# SWITCHBOARDS AT 3796 & N 1070 MODIFICATION TO PROVIDE TRANSMISSION FOR OPERATOR DURING P.B.X. POWER SUPPLY FAILURE

P. O.				
TELECOMMS.				
HQRS.	UE		,	
PAPER: W	S			
	တ	В	PAGE 2; ADDL. WIRING NOTES TRANSPOSED. MINOR CORRECTIONS. TO	9.12.68.
CIRCULATION	_	Α	NEW FORMAT FLR.	8 - 8 - 67
GENERAL		$\overline{}$	G.A.A. (S3) TDI. 5. 2 SECTION	8 - 9 - 61

## FOR SWITCHBOARD AT 3796

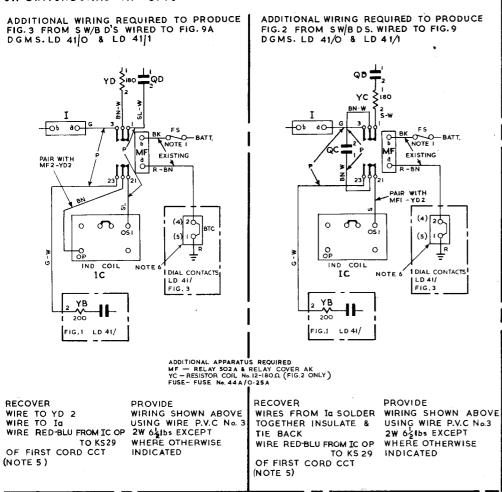
- A In the event of a power failure the cord circuits must be switched to night service otherwise the transmission performance of the operator's circuit will be impaired.
- B Only new installations of N1070 Swbds. to be modified.

# FOR SWITCHBOARD N 1070 (NOTE B, PAGE 1)

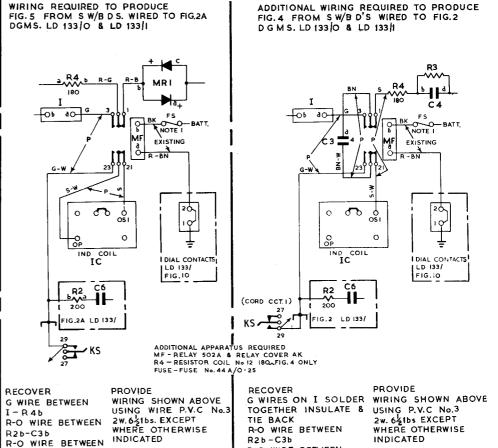
- I. Fuse rating 0.25A.
- 2. Fuse to be mounted in position marked Relay ES and relay MF in 5. All disconnected wiring to be insulated and tied back. position marked ES (on earlier swbds, read KS for ES). Where relay ES is fitted mount relay MF & fuse where convenient and provide additional wiring.
- 3. Relay armature, relay cover and fuse mounting to be sign written as appropriate.
- 4. Resistor YC (Fig. 2) R4 (Fig. 4) to be screwed to woodwork.
- 6. Terminals (4)(5) refer to Dgm. LD 41/0, terminal 1, 2 to Dgm. LD 41/1.
- 7. Wiring instructions for Fig.1 to be prepared locally.
- 8. Pasted-in label Diagram to be prominently marked "Modified and Sign written to Dgm. N 1099."
